PLANT NAME:
H. B. ROBINSON #2

RESPONSE TO QUESTIONS ON SPENT FUEL SHIPPING CRANE

CP&L RESPONSES TO NRC REQUESTS
FOR ADDITIONAL INFORMATION ON THE
SPENT FUEL CASK HANDLING SYSTEM
H. B. ROBINSON UNIT NO. 2, DOCKET NO. 50-261

ASSUME SHAFT FAILS
AND DRUM FALLS 1/8"
TO SAFETY LUG

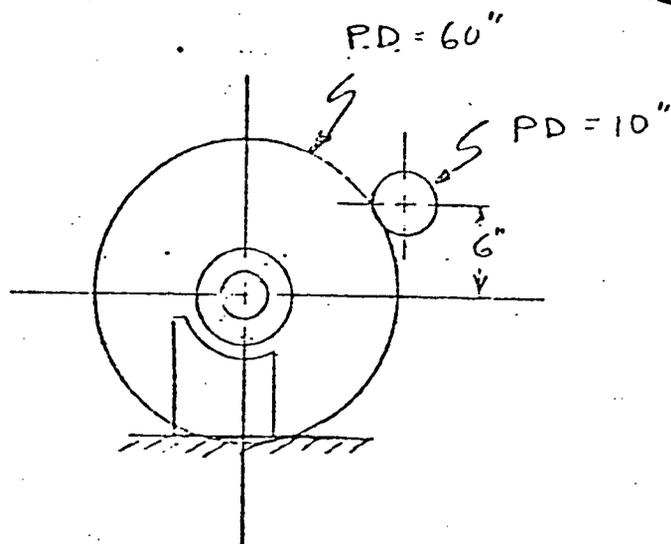
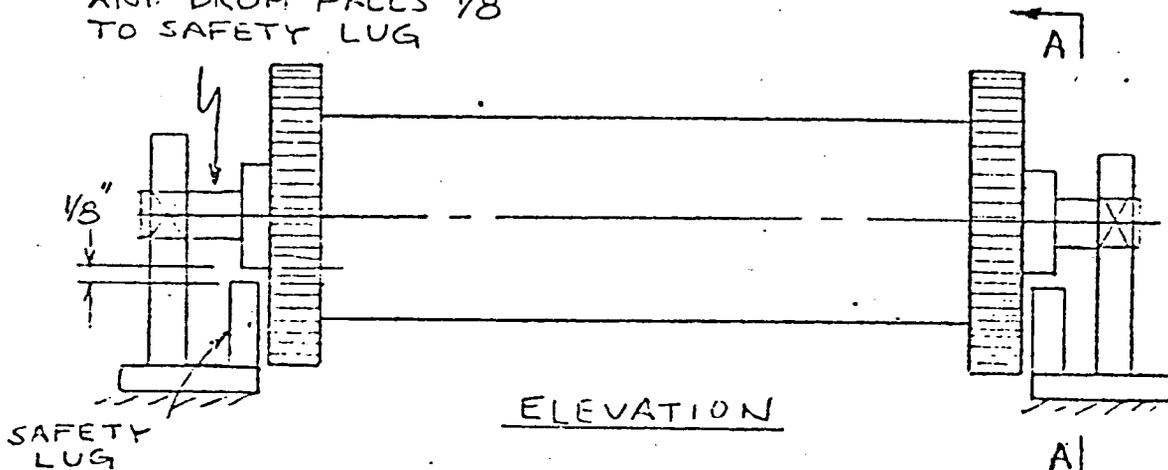
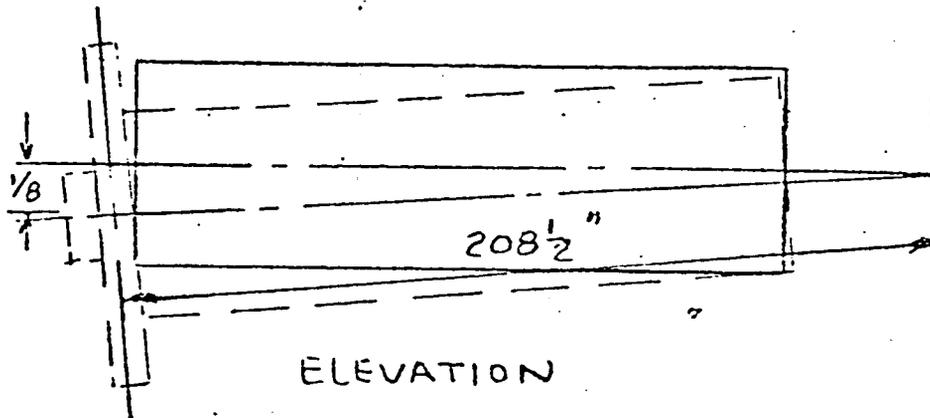
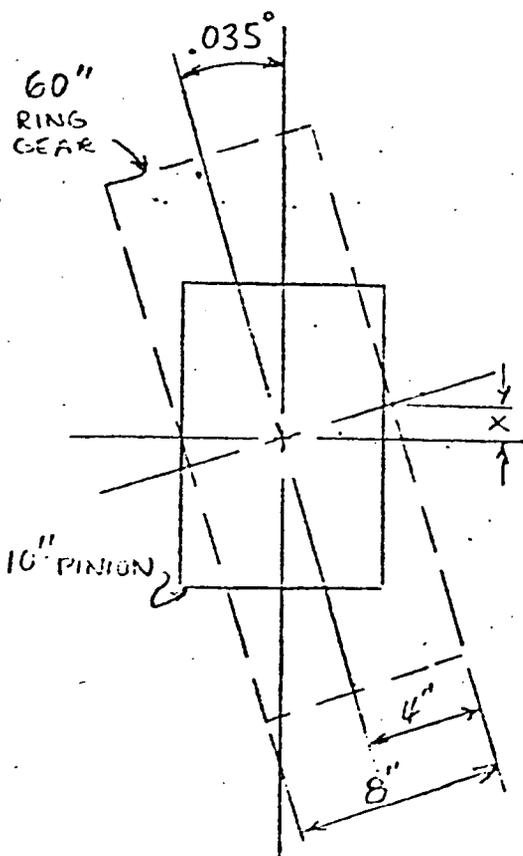
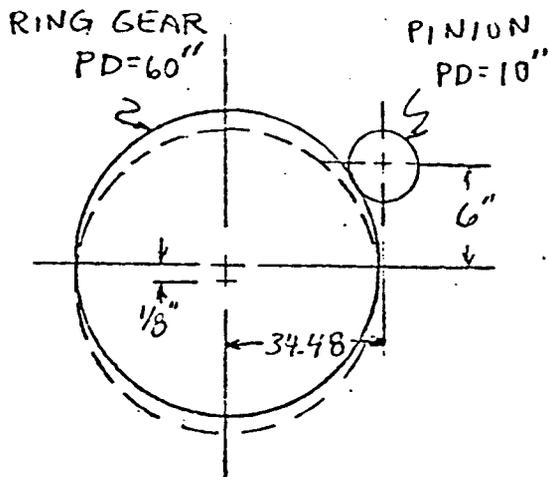
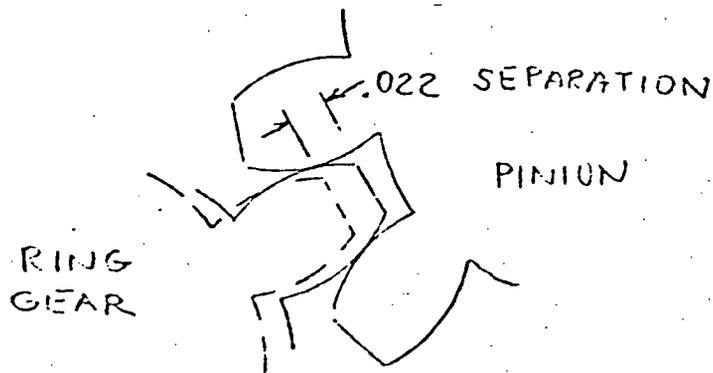
- 3.k. The main hoist drum is a single component, the failure of which would cause loss of the critical load. It is our position that mechanical restraints should be provided which will catch and hold the drum in the event of support failure at one end of the drum and which would allow for emergency lowering of the critical load. Provide details of the drum restraints including the amount the drum can drop in the event of an end support failure. Also, provide an analysis which shows that the misalignment on the gear train opposite the failed support as a result of the drum dropping is within the design limits of the gearing, and that the combination of misalignment and added friction of the drum on the restraint will not cause excessive loading on this gearing during emergency lowering of the load.

Response - Each end of the drum is provided with a hub which is concentric with the drum shaft. A safety lug, (receptacle) is built into the trolley frame on both ends of the drum. The safety lug has a surface which is concentric with the drum hub and is located 1/8" under the drum hub. In the event of failure of a drum shaft or support, the drum hub comes into contact with the safety lug which prevents the drum from falling. An analysis shows that the misalignment on the gear train opposite the failed shaft, or support, as a result of the drum dropping is within the design limits of the gearing, and that the combination of misalignment and added friction of the drum hub on the safety lug will not cause excessive loading on the gearing during emergency lowering of the load. The analysis is attached for information.

THEREFORE, THE ROTATION OF THE RING GEAR IS STILL WITHIN THE BACKLASH LIMITS.

THE RING GEAR MOVES 0.022 in. AWAY FROM PINION.

THERE IS NO EXCESSIVE LOADING ON THE GEARS OR ON THE MOTOR AFTER THE DRUM SHAFT FAILURE.
